# ***RICHARDSON GROVE OPERATIONAL IMPROVEMENT PROJECT***

## **Responses to Comments on the Addendum to the Final Environmental Impact Report**

**Humboldt County, California  
01 – HUM – 101 PMs 1.1 / 2.2  
01-46480 / 0100000266**

*January 2023*

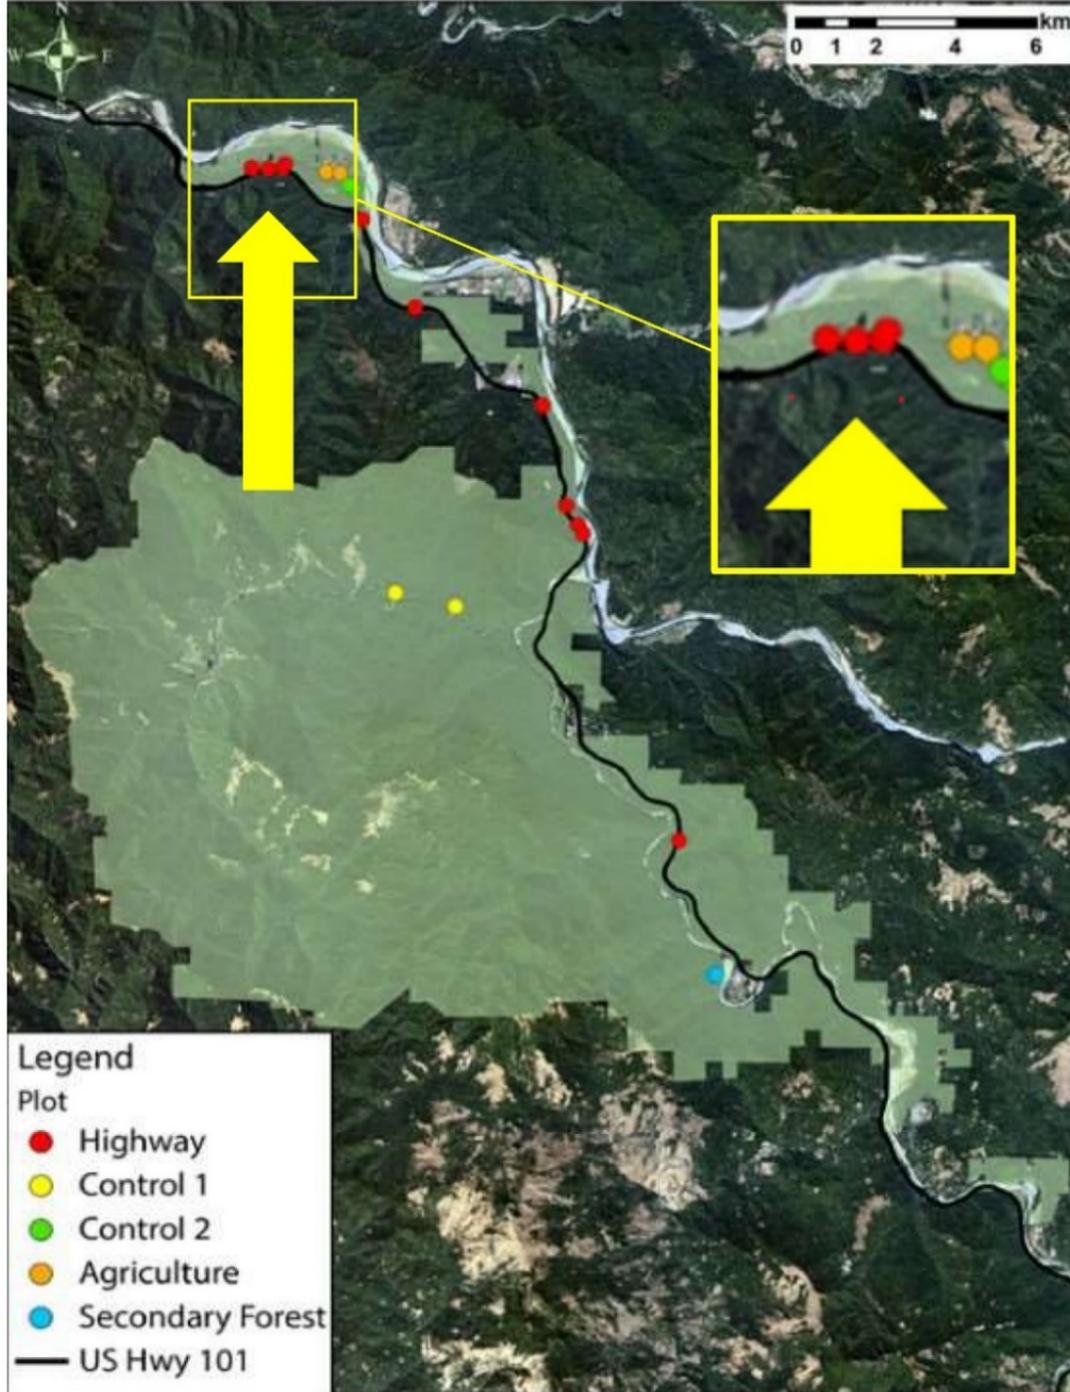
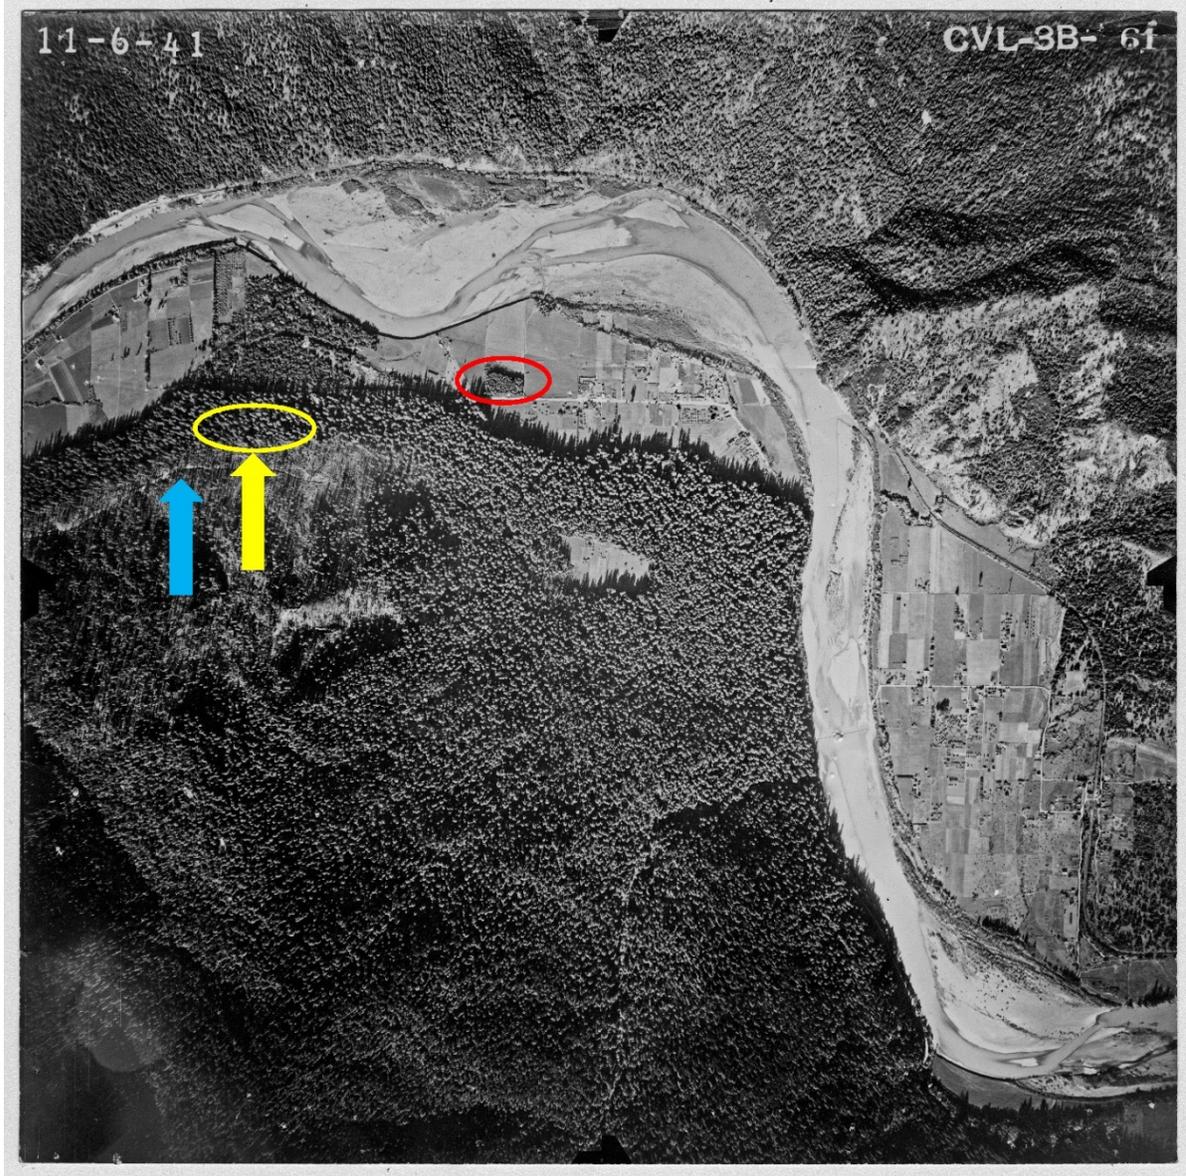
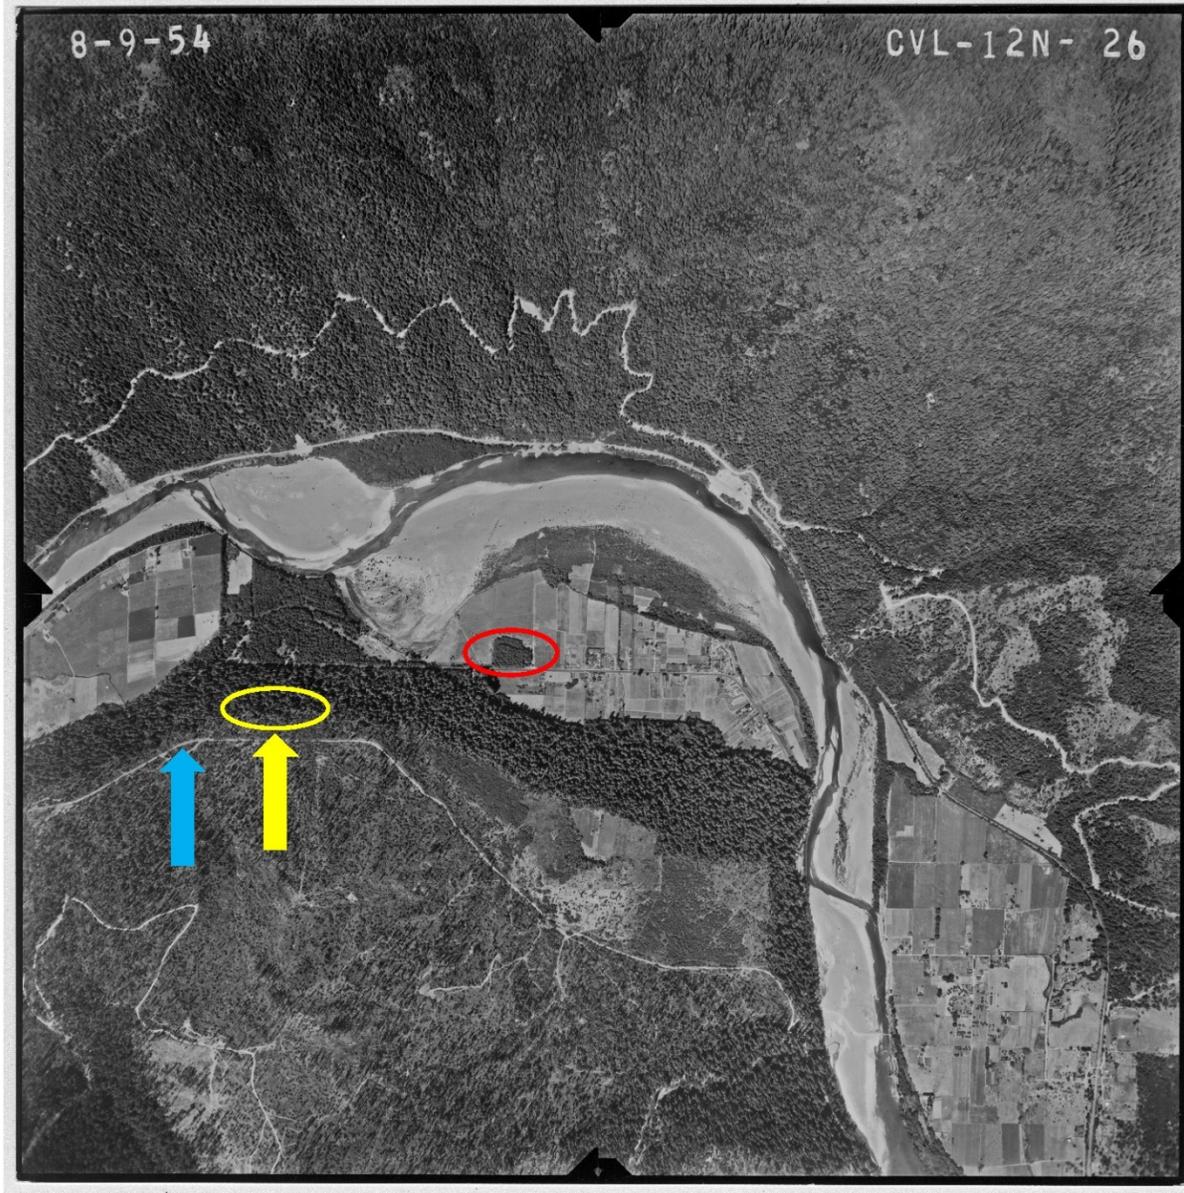
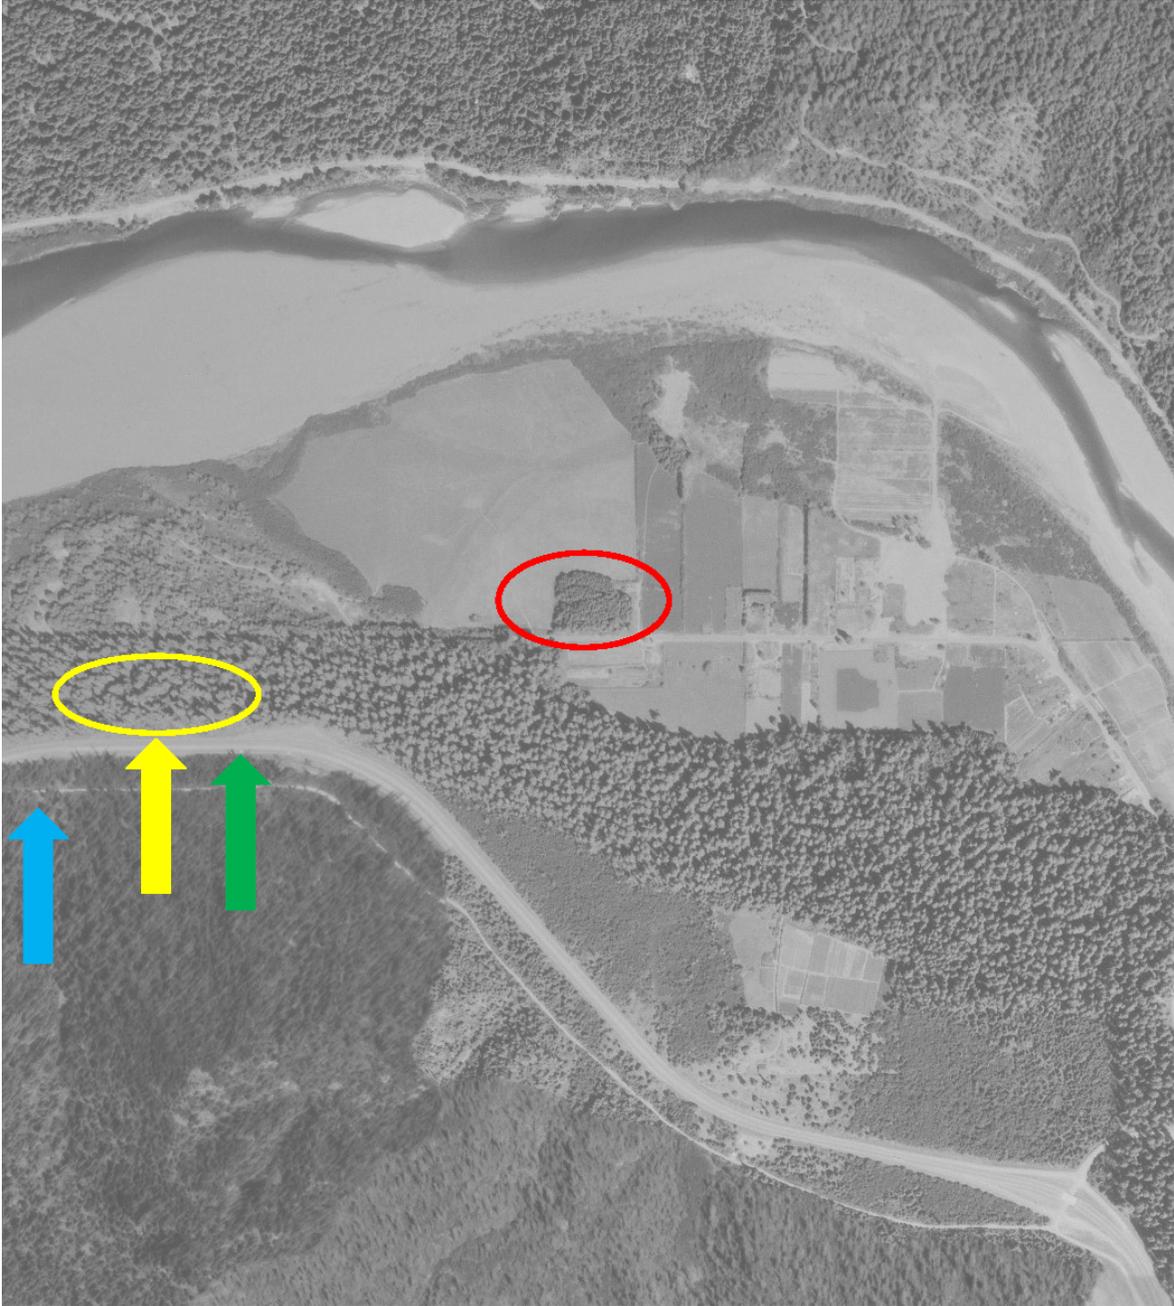
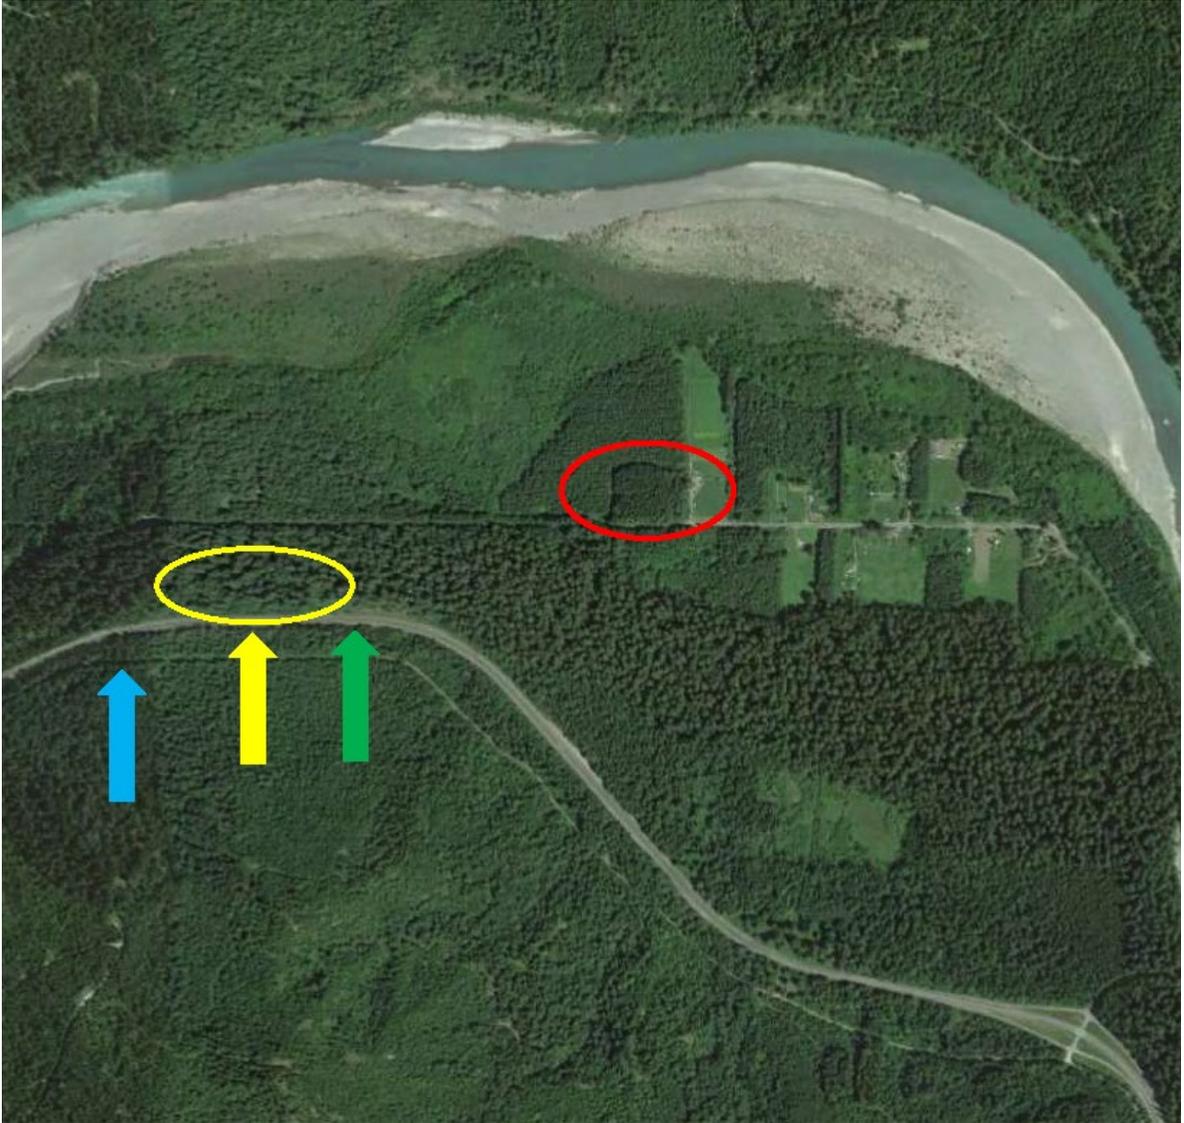
**Comment 3: The Dangerfield (2020) master’s thesis and Dangerfield (2021) article are new studies that should be considered.**

Both studies state the highway construction at Pepperwood took place from 1956 to 1960 and use those dates in analyzing old-growth redwood tree-ring growth patterns. The northernmost “highway-adjacent” trees sampled in the Dangerfield studies are located at approximately post miles 44.7 and 44.9. The project plans for the then-new section of US 101 to be built at this location were not approved until April 1965. Construction of the new highway was not completed until late 1967. Therefore, the tree-rings identified in the studies as corresponding to the dates of highway construction pre-date construction by five or more years.

as stated in the studies. Rather, the highway was built on the exact site where old-growth redwoods had already been disturbed and impacted by extensive logging beginning at least as early as 1941, close to the trees that had been selected and evaluated as the northernmost “highway-adjacent trees” in the studies (Figures 1 through 5).

The northernmost highway-adjacent trees in the Dangerfield studies were exposed to the edge effects (including increased air and soil temperatures, decreased humidity, and increased wind) of adjacent heavy logging for about 24 years *before* the new section of US 101 was constructed. As the 2021 Dangerfield study states, “While dieback can occur naturally in redwoods due to age and accumulation of damage from other disturbances or even previous periods of extreme drought . . . *we did not attempt to date the dieback in the trees we sampled to differentiate between old and new dieback events.*” [Emphasis added.] The Dangerfield studies do not evaluate whether, or to what extent, the prior logging operations on and directly adjacent to the site of US 101 construction contributed to crown dieback or a reduction in tree-ring growth increments of sampled trees.

**Figure 12. Tree Root Zones (from the FEIR Addendum)**

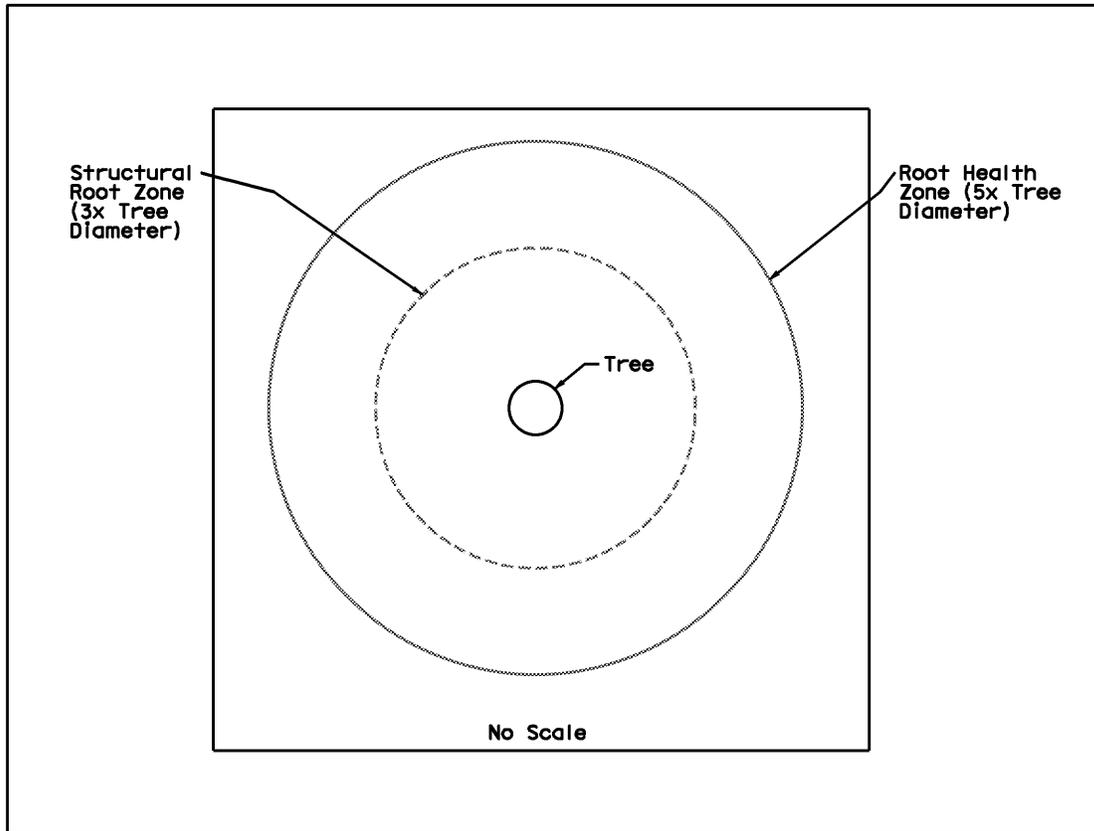
**Comment 4: The International Society of Arboriculture defines the “critical root zone” (CRZ) as a 1-foot radius from the base of the tree’s trunk for each 1 inch of the tree’s diameter at 4.5 feet above grade and recommends avoidance of construction activities within that zone. The 2021 Dangerfield study supports use of this methodology. Use of the CRZ method would expand the number of old-growth redwood trees subject to analysis.**

The commenter’s definition of CRZ is not supported by the International Society of Arboriculture (ISA). According to the most recent edition of the ISA’s Best Management Practices (Matheny et al., 2022), a critical root zone (CRZ) is the “area of soil around a tree where the minimum amount of roots critical to the structural stability or health of the tree are located. *There are no universally accepted methods to calculate the CRZ*” (Matheny et al., 2022). [Emphasis added.] An acceptable methodology for determining potential impacts of root disturbance to trees would be based on an evaluation of such factors as tree species, age, condition, root configuration, soil characteristics, site conditions, and the severity of the root disruption (Fite and Smiley, 2016). These concepts have been confirmed by the ISA in 2022.

The CRZ is one method of analyzing impacts to trees. As acknowledged by the commenter, there are various methodologies to conduct such an analysis. The Department’s analysis, as documented in the 2015 Tree Report, examined the areas around all 109 old-growth redwood trees where some part of their root health zone (RHZ) fell within areas of proposed project activity. The RHZ is a circular area with the tree trunk at the center and a radius equal to five times the tree trunk diameter measured 4.5 feet above ground level. Of the 109 trees analyzed in the 2015 Tree Report, 78 trees would be subject to project activity within their structural root zone (SRZ) (Yniguez 2015). The SRZ is a circular area with the tree trunk at the center and a radius equal to three times the tree trunk diameter measured 4.5 feet above ground level (California State Parks 2011b) (Figure 12).

According to the ISA, the CRZ is subjective and there is no accepted calculation to define it biologically (Fite and Smiley, 2016), rendering it impossible to determine whether more old-growth redwood trees would have been subject to analysis using that method.
